NUREG-2246

# FUEL QUALIFICATION FOR ADVANCED REACTORS

**Draft Report for Comment**

**Table B-1 Public Comment Submittals on Draft NUREG-2246**

**Figure 3-1 Decomposition of the Main Goal**

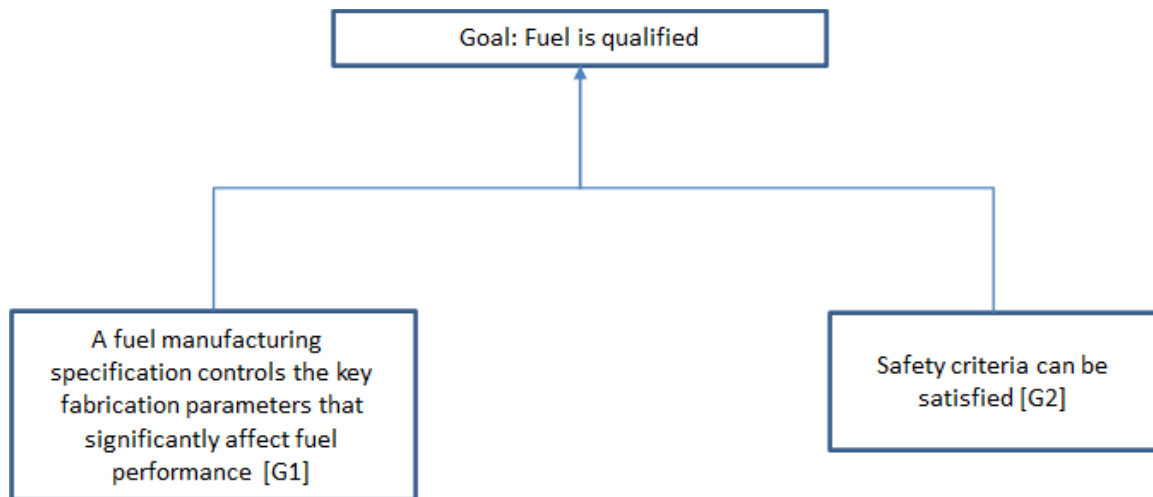
The main goal decomposition does not seem correct (Fig. 3.1). G1 and G2 not only goals for fuel qualifications. The manufacturing process and safety criteria vs. qualification? Truly not sure about it. Can you formalize, which “fabrication parameters significantly affect” what? At the same time, below “complete manufacturing specification is not expected as part of the licensing documentation”...

The NRC staff made no changes to NUREG-2246 in response to this comment.
